# Proposed St. Paul's Residential Development, Raheny, Dublin 5

**Stage 1 Road Safety Audit (for Planning)**

- 1.1 Title** RSA ST PAULS S1
- 1.2 Audit Reference Number** RSA ST PAULS S1 KS 299
- 1.3 Project Code** STPAULS
- 1.4 Date Audit Completed** 26<sup>th</sup> August 2019
- 1.5 Audit Attended By** Ken Swaby  
Mark Andrews
- 1.6 Audit Team**
  - Team Leader** Ken Swaby, ILTP
  - Team Member** Mark Andrews, ILTP

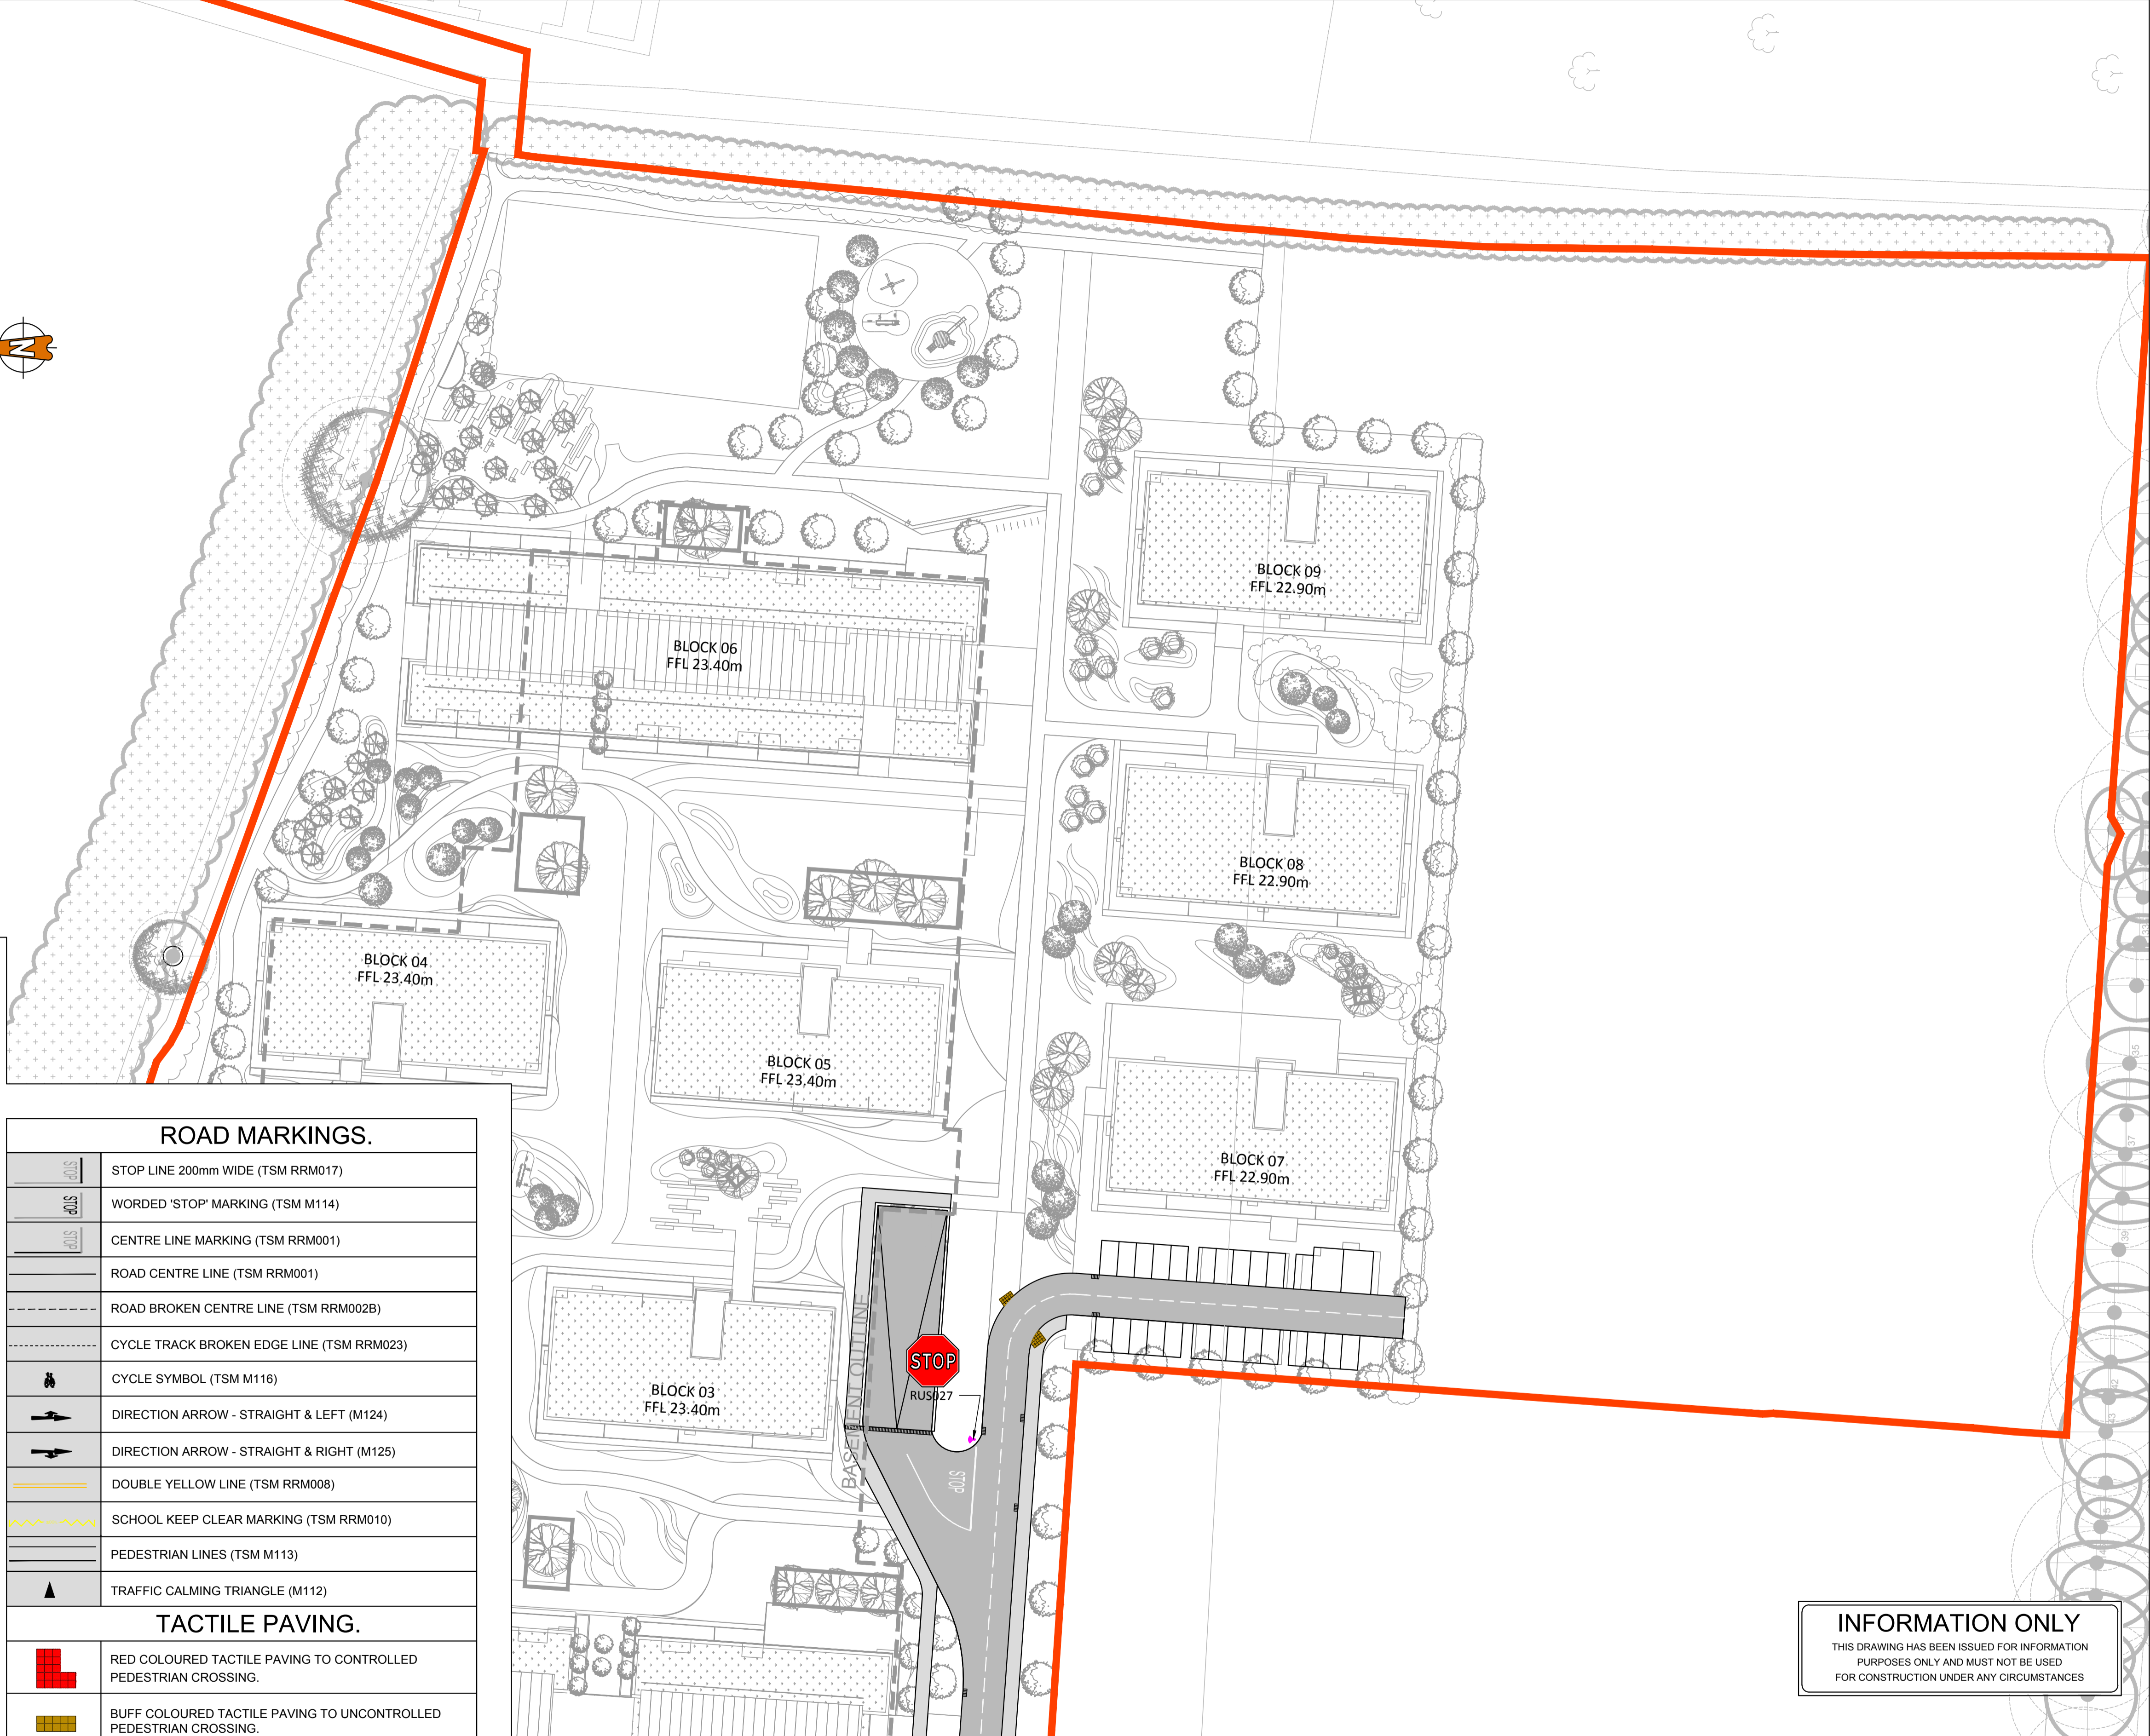
The information provided for audit does not indicate pedestrian crossing facilities of the main access road to the development in the vicinity of the basement access junction and to the west of Block 7 (refer to Figure 4.1). This area may be likely to have a number of pedestrian desire lines to and from the proposed development. Without appropriate pedestrian crossing facilities vulnerable road users may enter the carriageway in inappropriate locations, coming into conflict with other road users.

4.1.2	Y	Y	Uncontrolled Pedestrian crossing will be provided with appropriate tactile paving in the area in question. For crossing details refer to drawing N251-F02 attached.	Y See Note 1 below.
